Summary Architectural Heritage Assessment

Date of issue: 19th May 2025

Development: Clare Glens River Walk

Figure 1: Proposed site plan for Clare Glens River Walk

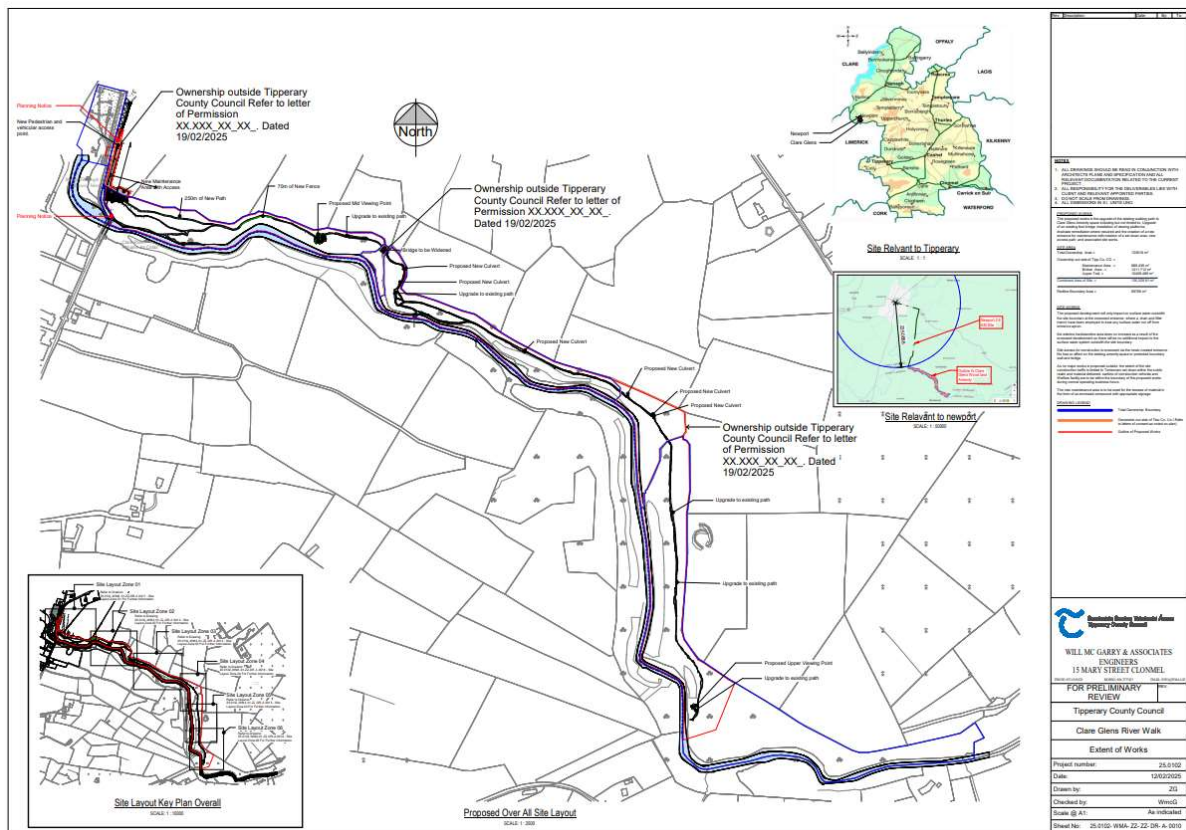
The proposed works to the rest of the site, as detailed on drawings are not foreseen to have any potential negative impact on the historic fabric or character of Clare Bridge (*figures 7, 8 and 9*), a protected structure and recorded archaeological site, or on any other historic items along the route of the proposed development.

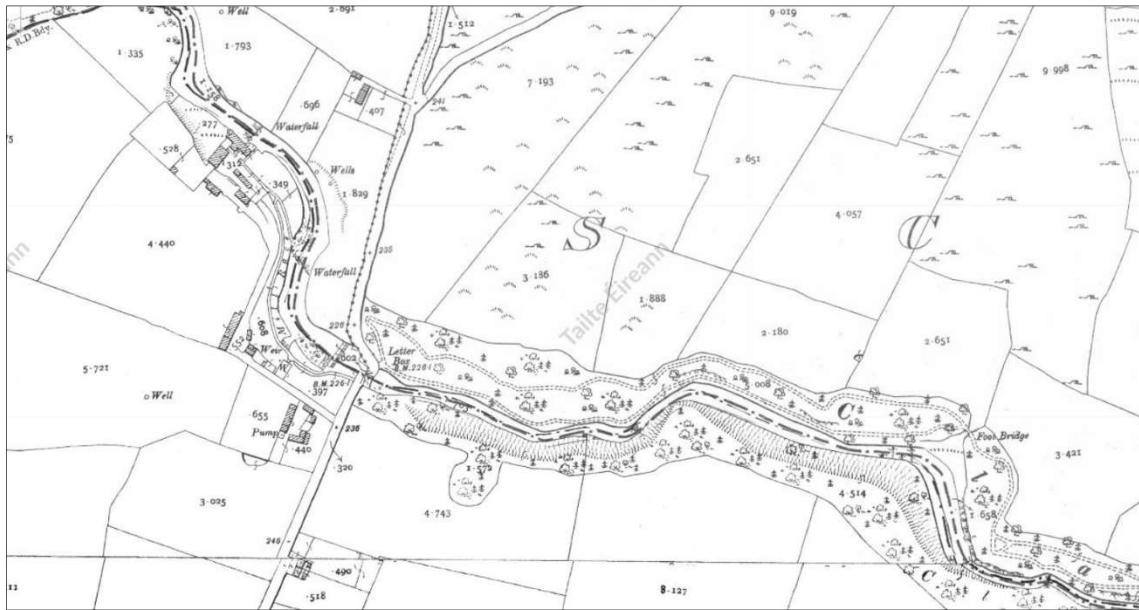
The replacement of the existing footbridge (*figure 11*) some 475m east of the protected Clare Bridge will involve removal of an existing twentieth-century concrete bridge on the same site of a historic footbridge depicted on the 1903 OS map. As such, there will be no loss of historic fabric or character from this unprotected structure and the proposed works to build a new bridge here (*figure 12*) will facilitate the appropriate continued and enhanced use of the foot path that has existed on this site for over a century.
